ORIGINATION FORM

Proposed Revisions to a Standard Plans Index

Index Number: 521-650

Index Title: Light Pole Pedestal - Wall Coping

TABLE 1 DESIGN LIMITATION FOR ANCHOR BOLTS (1" Dia.)

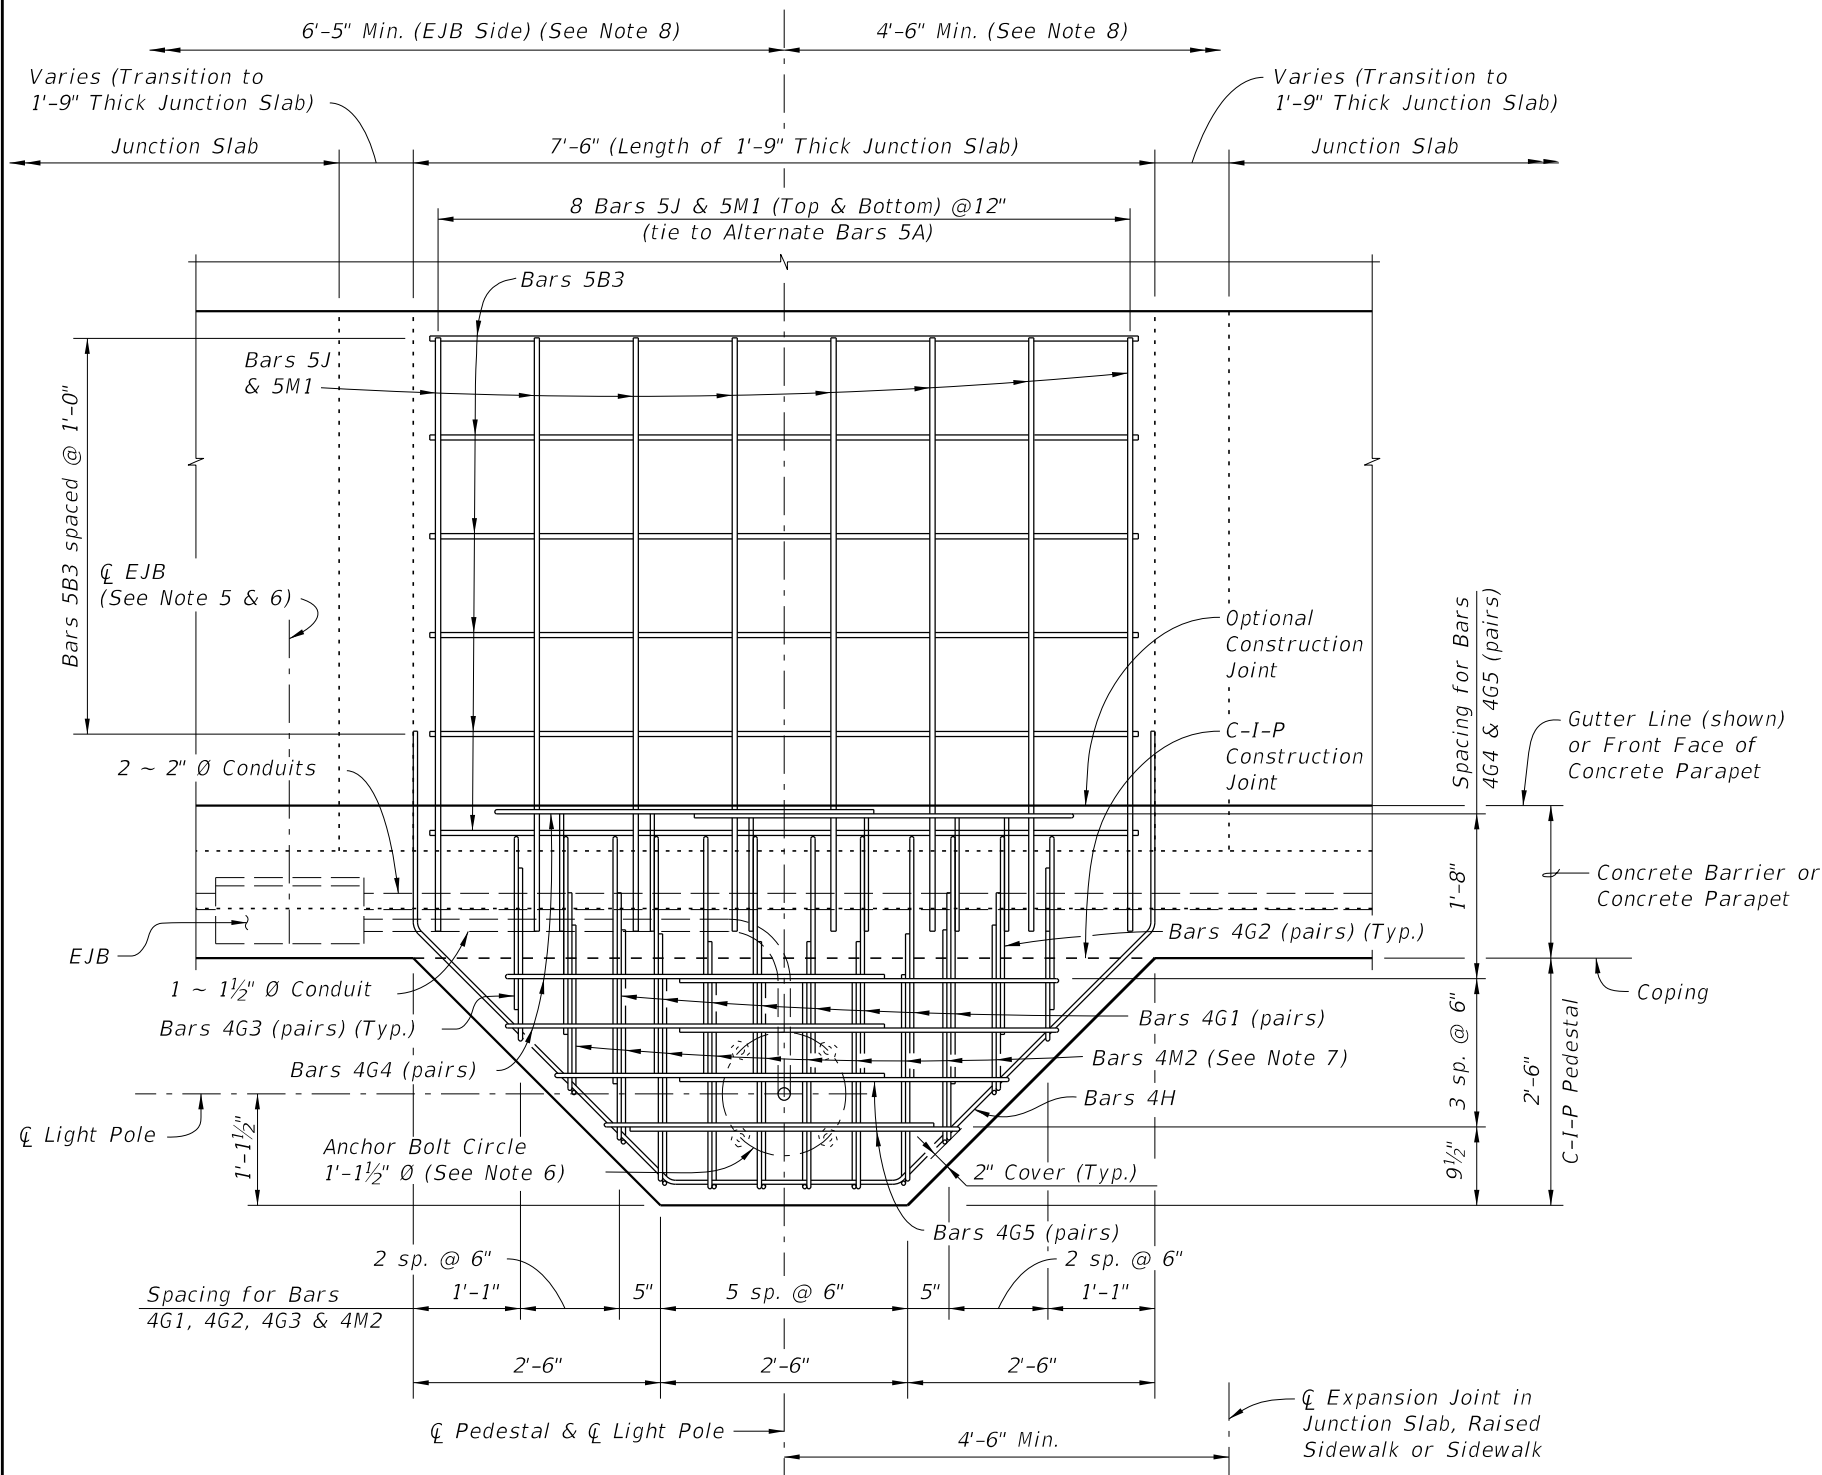
Sheet 1: Table 1 - Changed the column headings to "Top of Pedestal Height (Ft.)" and "Luminaire Mounting Height";

Sheet 1: The Table 1 column headings were revised to better define the height restrictions shown

Top of Pedestal Height (Ft.)*
Luminaire Mounting Height

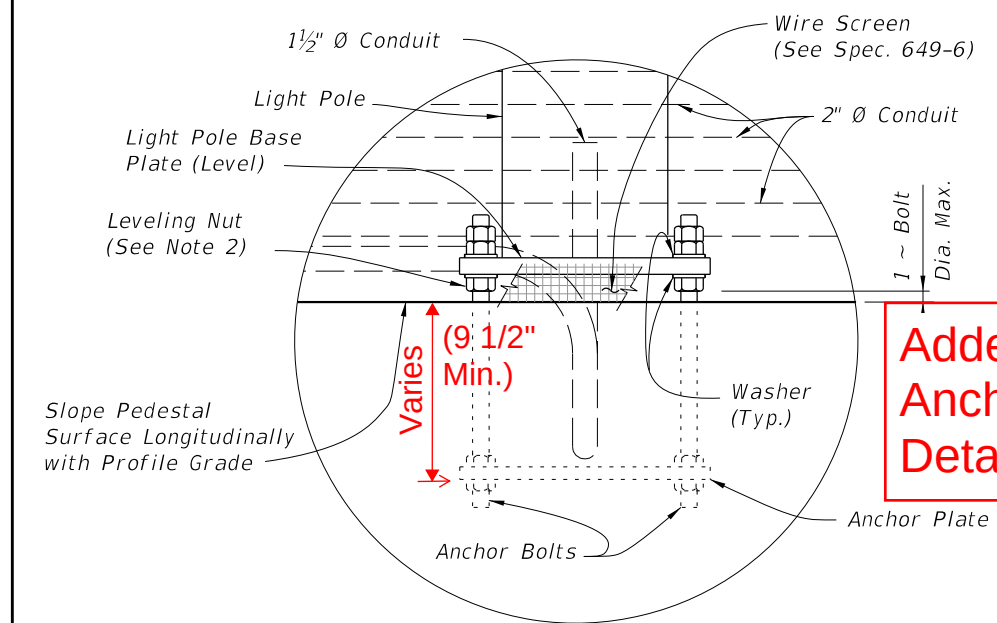
Sheet 3: Detail "A" - Added minimum depth for base plate; Added new Anchor Plate Detail

Sheet 3: More information was provided to clarify the anchor plate design and placement. The new anchor plate detail is based on Index 521-660, Sheet 4.

Added new Anchor Plate Detail
